ADDENDUM # 001

ST. CLAIR CATHOLIC DISTRICT SCHOOL BOARD
ST. JOHN FISHER CATHOLIC SCHOOL

TENDER NO.: 632-CP1505

Issue Date:
Wednesday May 13, 2015

PLUMBING
SCALE = 1:50

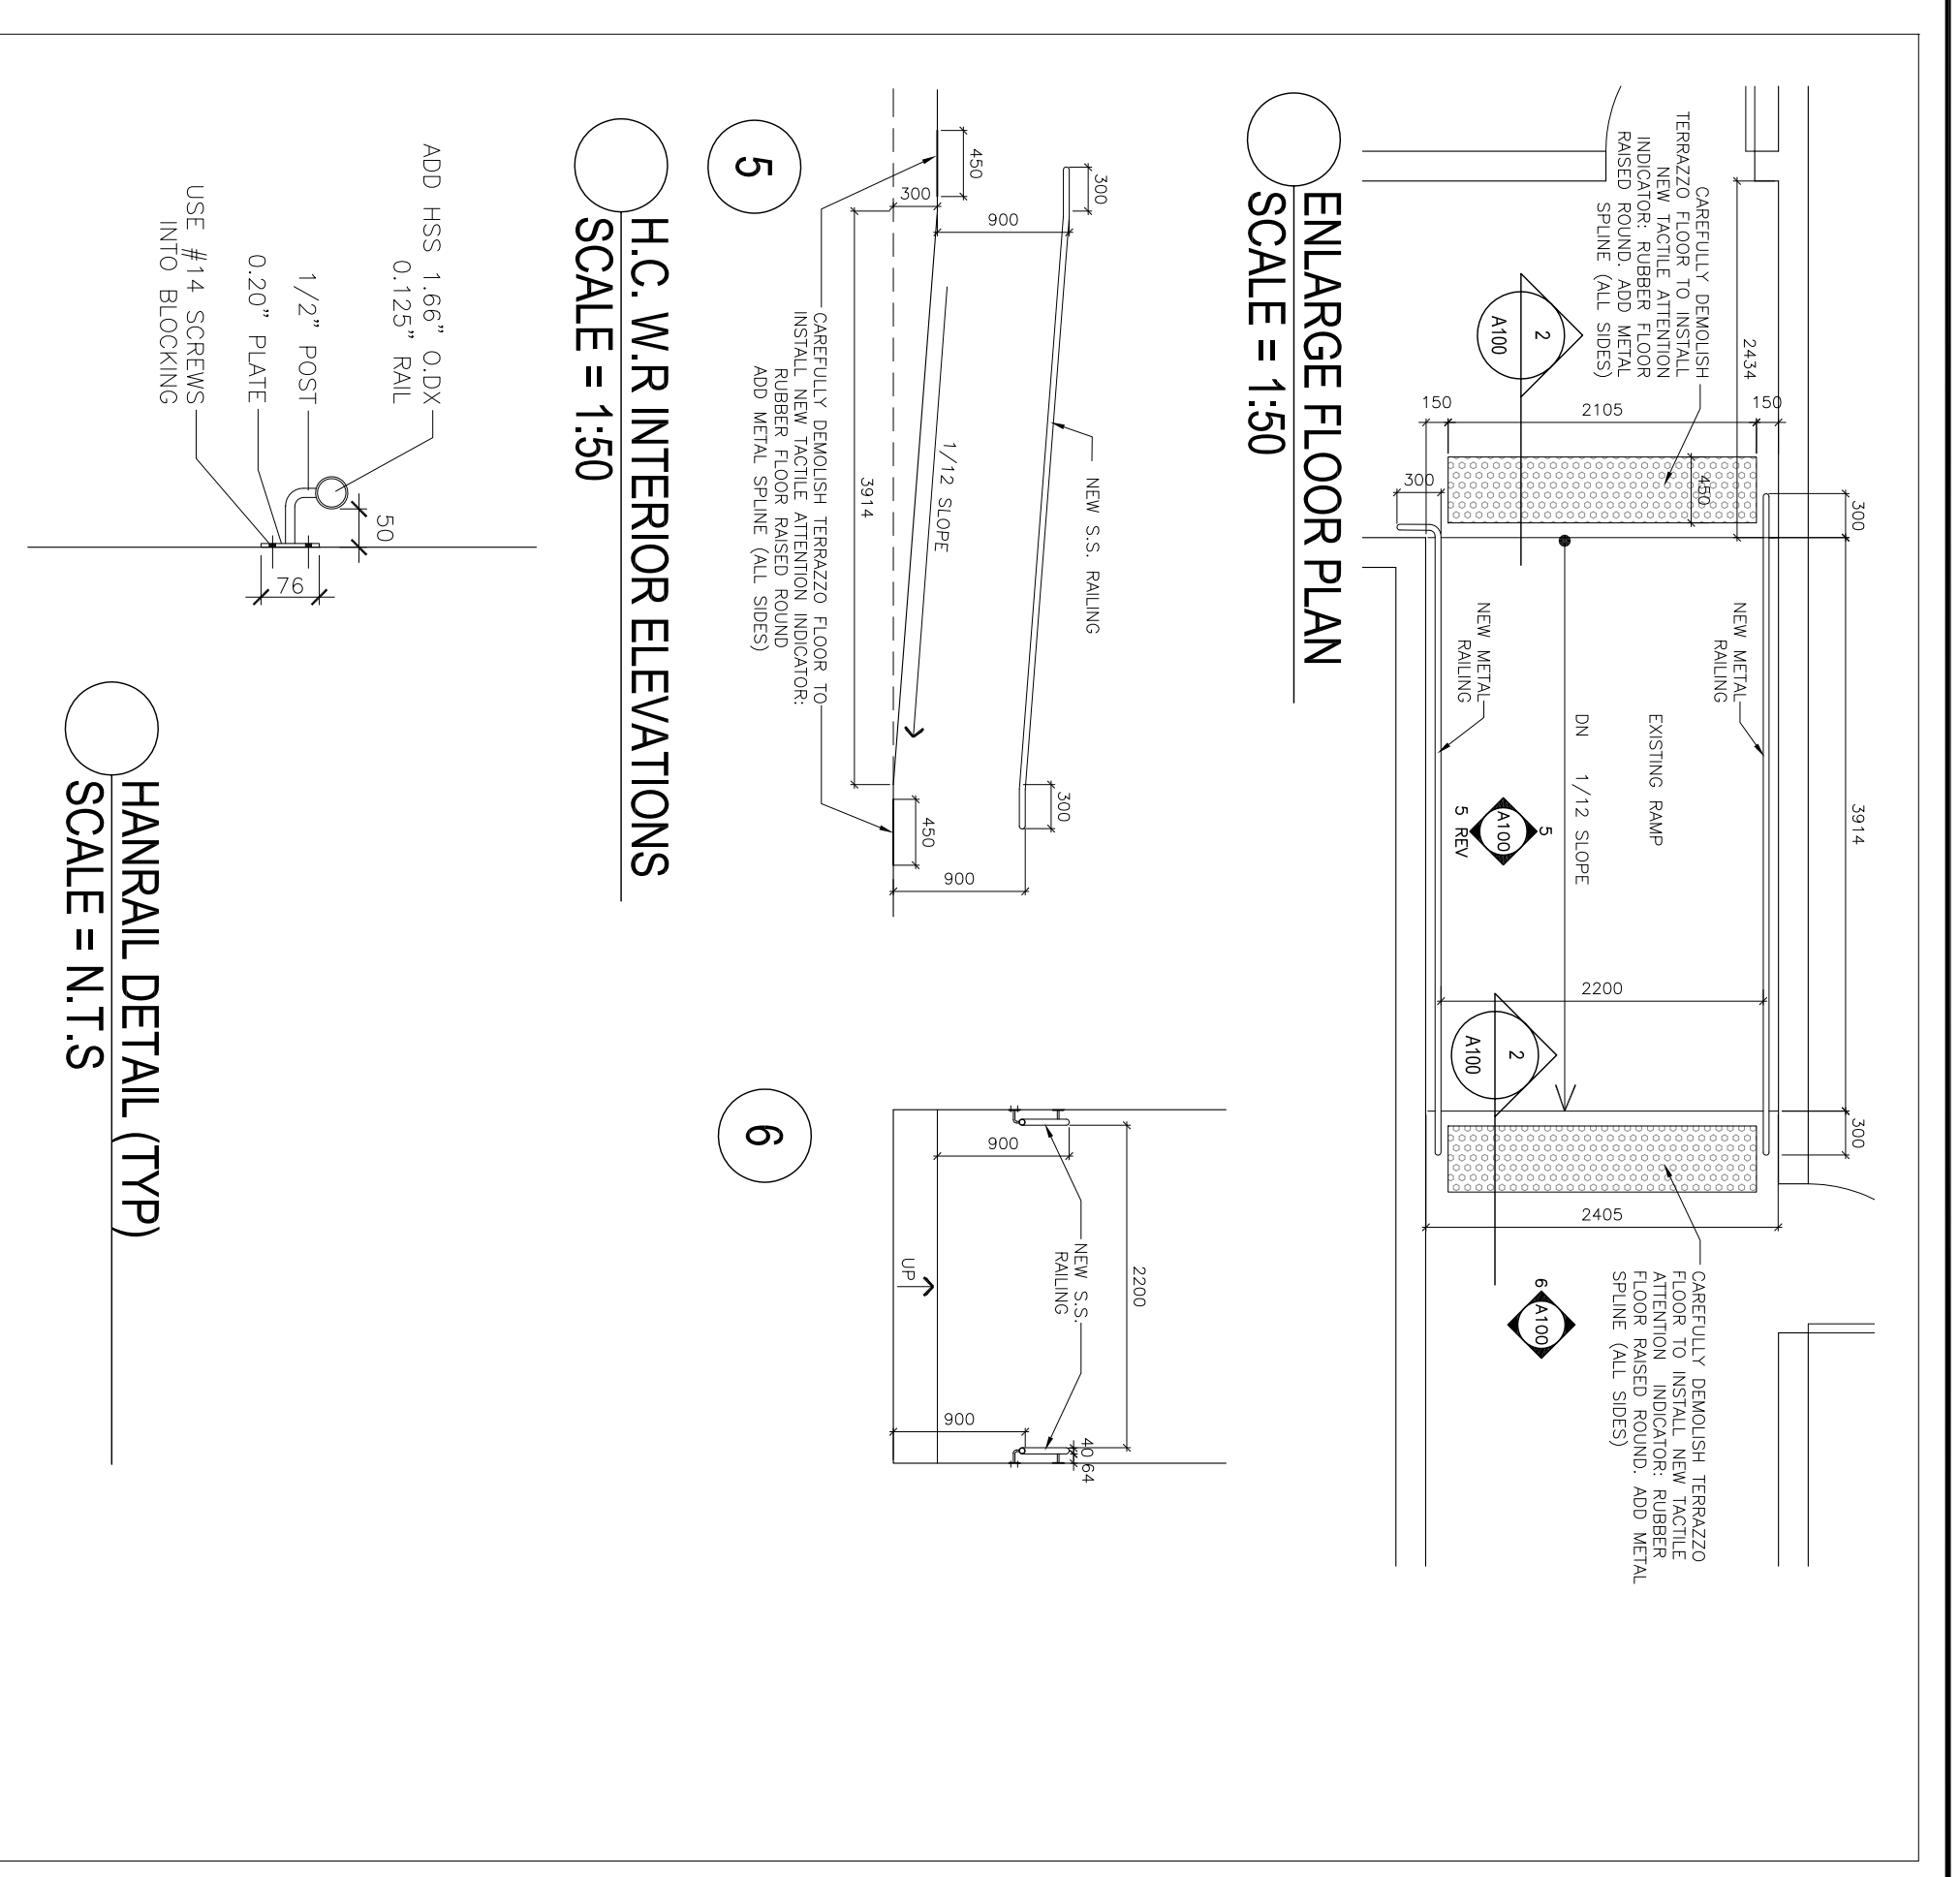
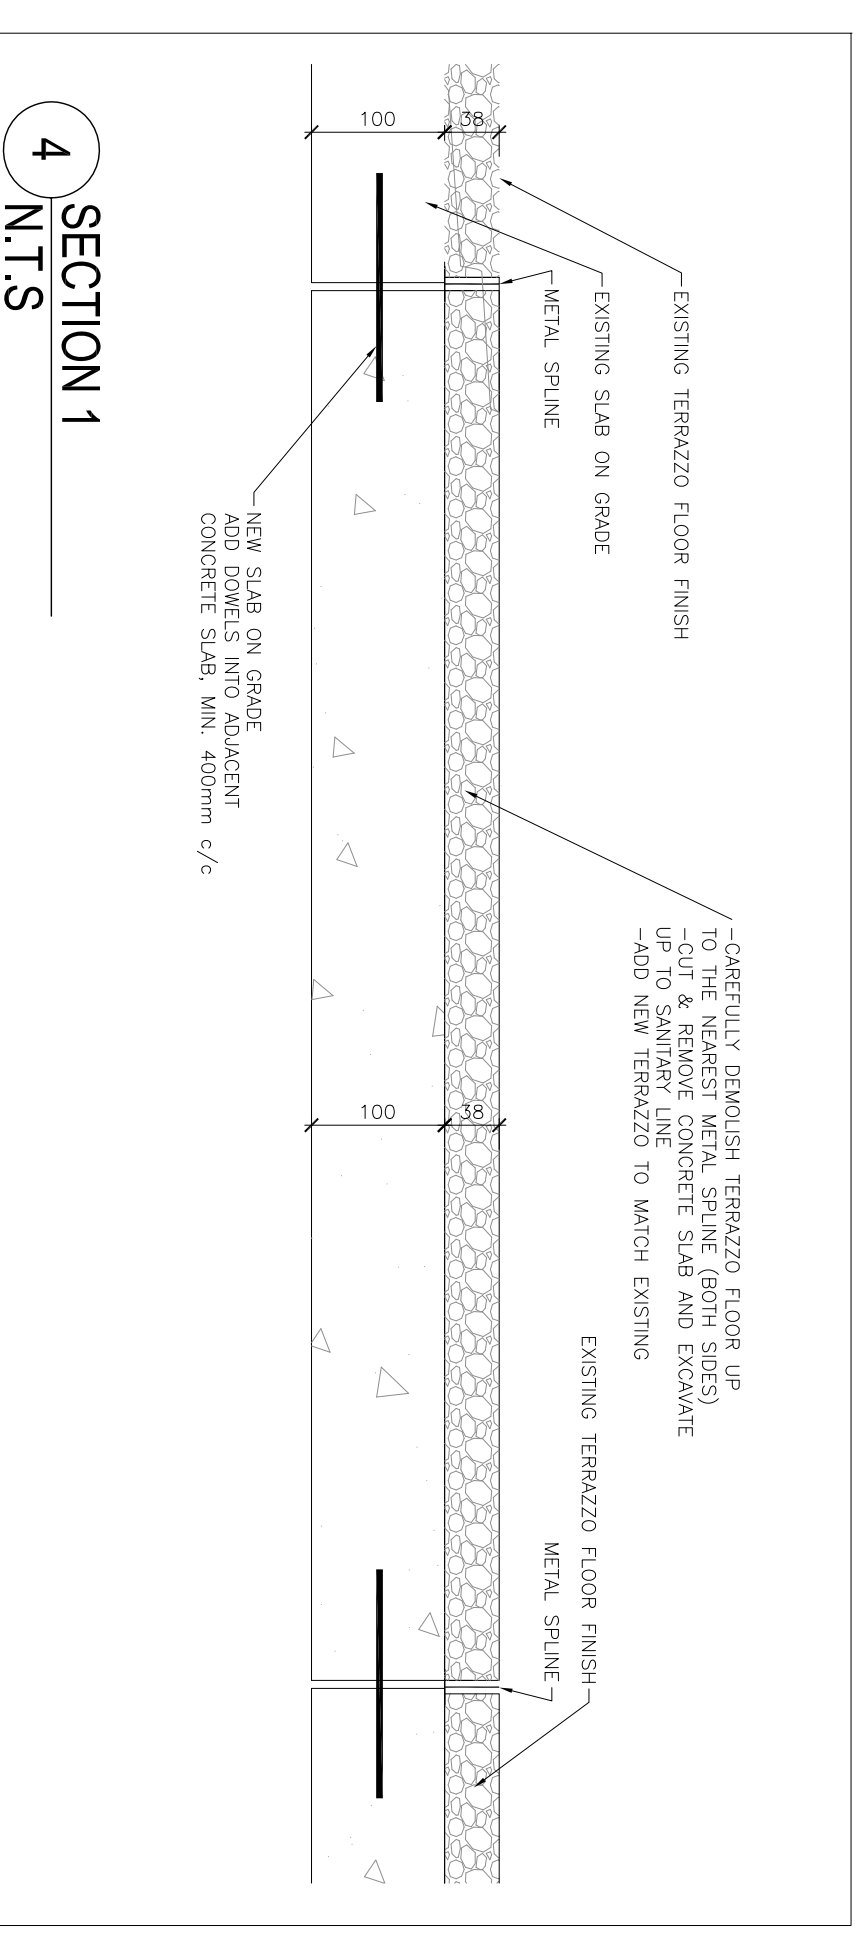
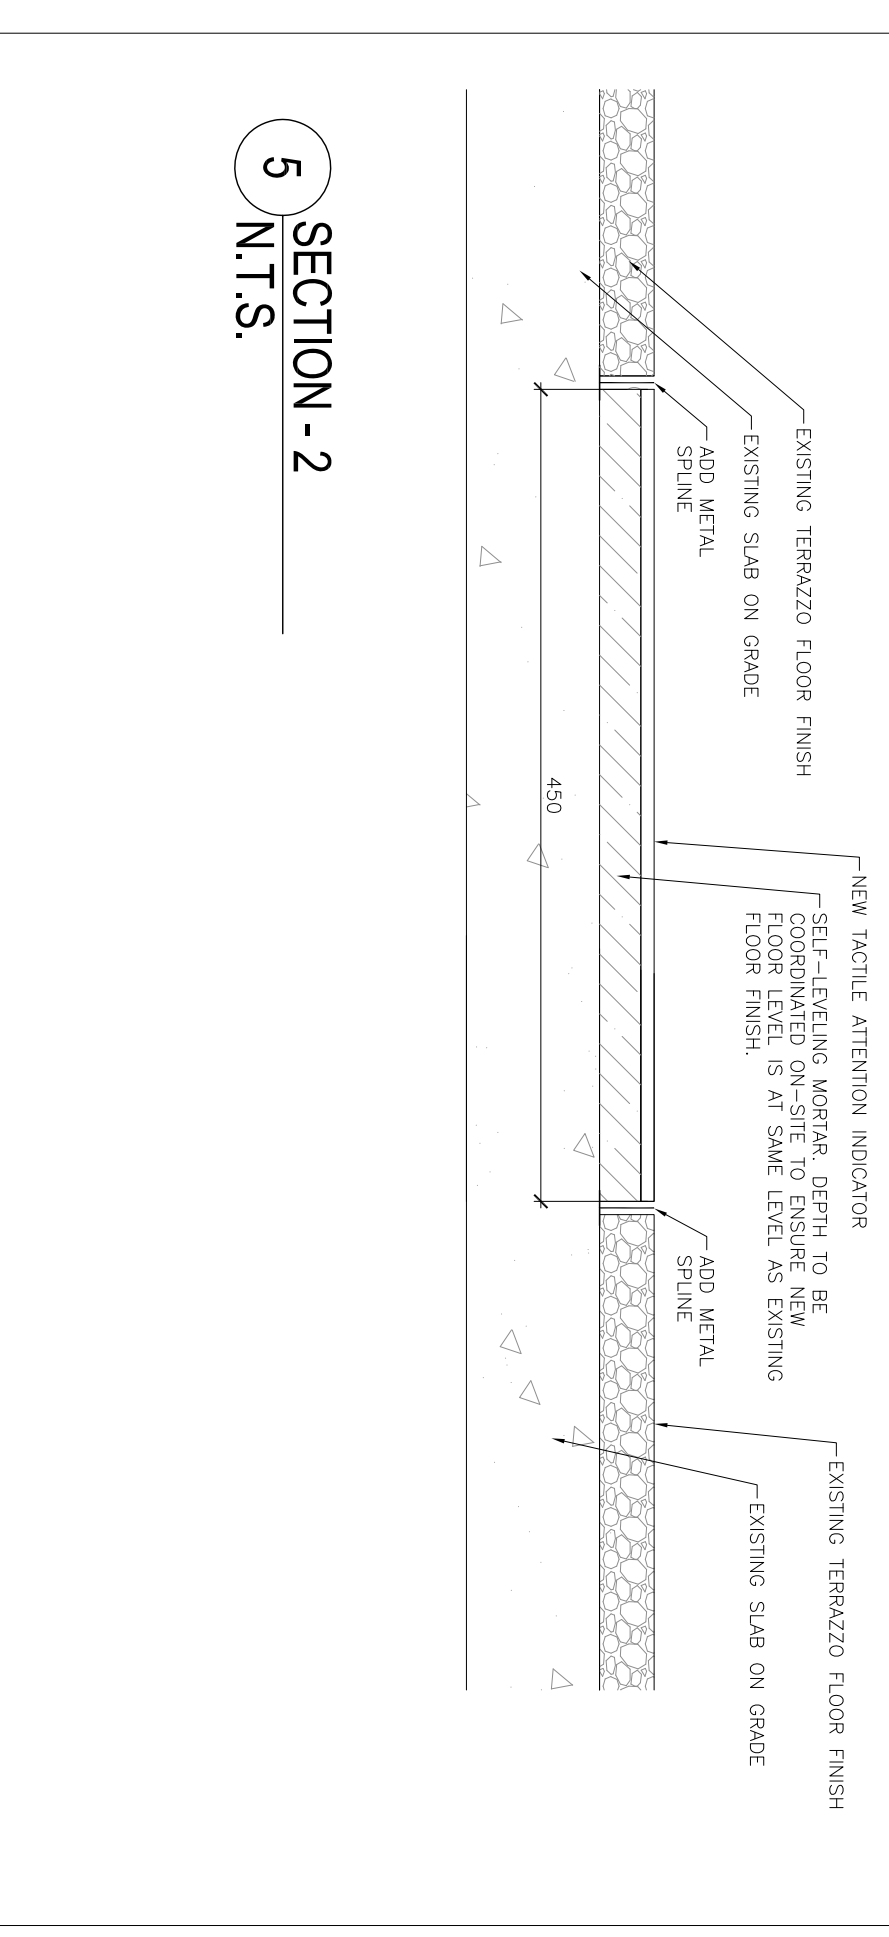
Refer to revision clouds and addendum 1 tags for changes to drawing.
